Access Compliance Report

Public Rights-of-Way (Curb Ramps)

Intersection ID: 17486	Main Street: SELWYN_AV	Cross Street: STERLING_RD	Location: W
ADA ID: 7F694F92C119	Ramp Type: Directional1	Initial Pass/Fail: Fail	Overall Compliance: No
Codes/Mitigation Info/Possible Solution		Field Measurements/Component Compliance	
Severity Score: 1.25

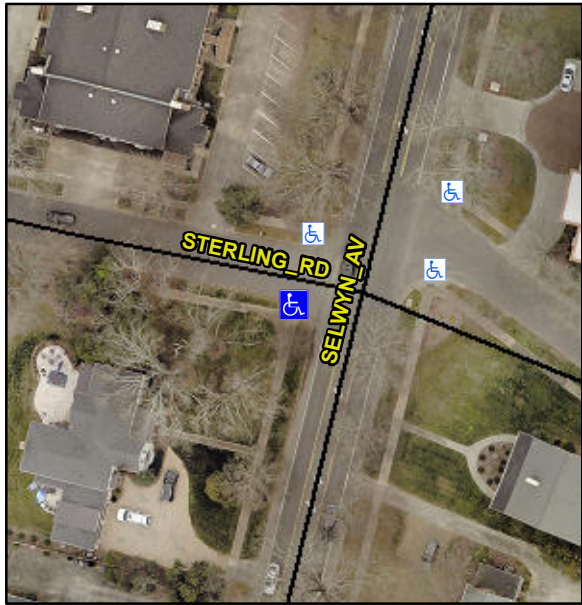
R304.5.3

Compliance	Description	Data	Compliance	Description	Data
N/A	Ramp Length (in)	82.0	N/A	Grade Break?	N/A
Yes	Ramp Width (in)	60.0	N/A	Grade Break Slope (%)	0.0
Yes	Ramp Slope (%)	1.5	N/A	Grade Break XSlope (%)	0.0
No	Ramp XSlope (%)	2.6			
N/A	Flare Type LT	N/A	N/A	Flare Type RT	N/A
N/A	Flare Slope LT (%)	N/A	N/A	Flare Slope RT (%)	0.0
N/A	Flare Traversable LT?	N/A	N/A	Flare Traversable RT?	N/A
N/A	Landing Length (in)	0.0	N/A	DWS Provided?	N/A
N/A	Landing Width (in)	0.0	N/A	DWS Contrast?	N/A
N/A	Landing Slope (%)	0.0	N/A	DWS Length (in)	N/A
N/A	Landing X Slope (%)	0.0	N/A	DWS Full Width?	N/A
N/A	Landing Curb? (Y/N)	N/A	N/A	DWS Offset LT (in)	N/A
N/A	Shared Landing?	N/A	N/A	DWS Offset RT (in)	N/A
N/A	Gutter Ponding?	0.0	N/A	Gutter Slope (%)	N/A
N/A	Gutter Lip Ht (in)	0.0	N/A	Gutter X Slope (%)	N/A
N/A	Painted X Walk1?	No		Road Slope (%)	0.6
	X Walk 1 Direction	To N		Road X Slope (%)	3.0
	X Walk 1 Width (in)	N/A		Clear Space?	N/A

Remove & Replace Entire Ramp.
